**1601 E AMERICAN BLVD
HILTON GARDEN INN - CORRIDORS & GUEST RO**

Originating Department Community Development	By GPD	Approved for Agenda by:	Date: Time:	Number:
Agenda Section DEVELOPMENT BUSINESS		Item Rezoning, Preliminary and Final Development Plan

Case 9294A-97

Request: Rezone property from FD-1 to FD-1(PD), Preliminary and final development plan for a 202 unit hotel

BUILDING ELEVATIONS		DATE: JUNE, 1997	
DATE:		DESIGNER:	
DESIGN BY: JJA		PROJECT:	
PROJECT: HERITAGE INN 203 UNIT MOTEL		LOCATION:	
JJA		PREPARED BY: JJA-JJA	
BLOOMINGTON, MN.

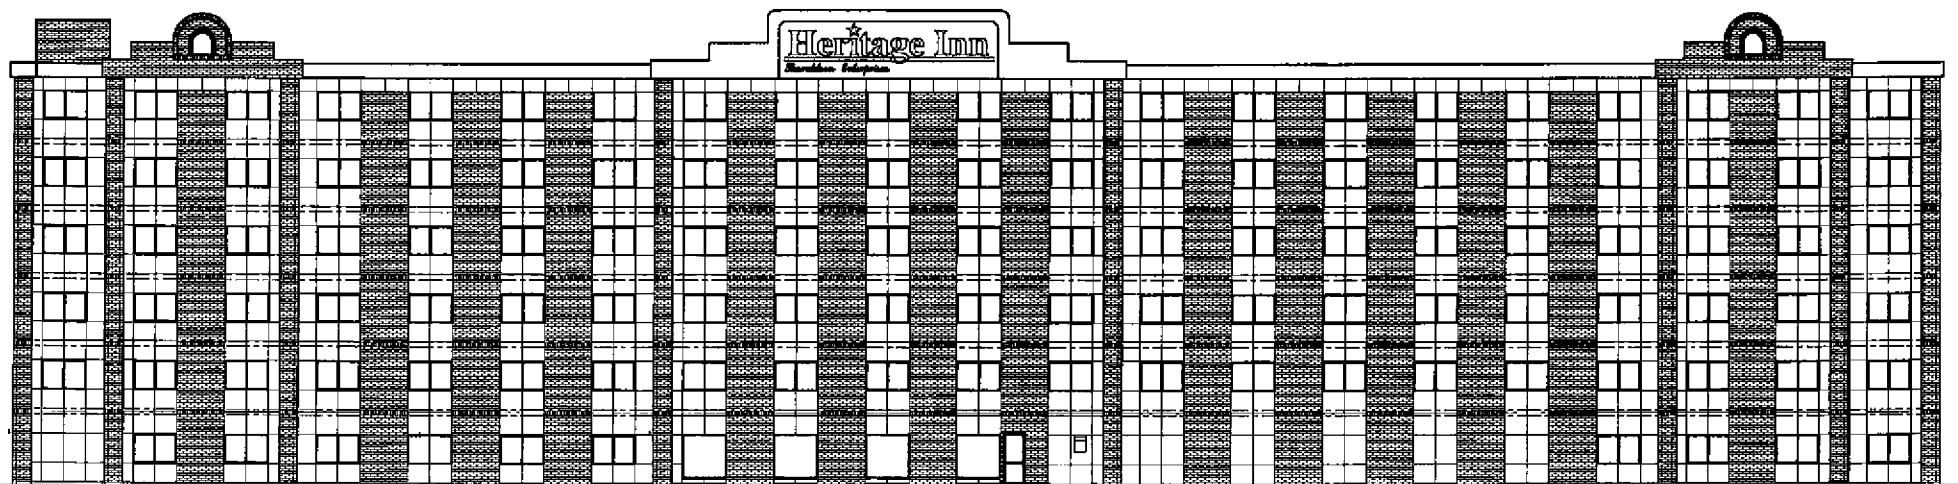
Revised hotel building elevations now show an exterior finish of three types of brick and have eliminated the use of any noncomplying materials. Staff does have some concern over the proposed elevations and will be discussing additional detailing with the developer to break up the long rectangular facades.

Plan View
Scale - 1" = 20'

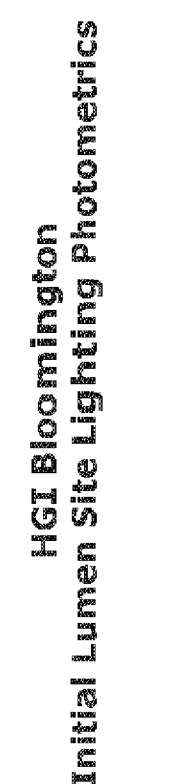
- 1) **No Certificate of Occupancy without inspection.**
CODE REQUIRES compliance with the approved plan. Individual points may not vary more than 20 percent with the average of all points within 10 percent of the initial foot-candle level on the approved initial plans.
 - 2) **No change in fixture by manufacturer, type or order number without review and approval shall be permitted.**
- Call 952-563-8920 to schedule an inspection.
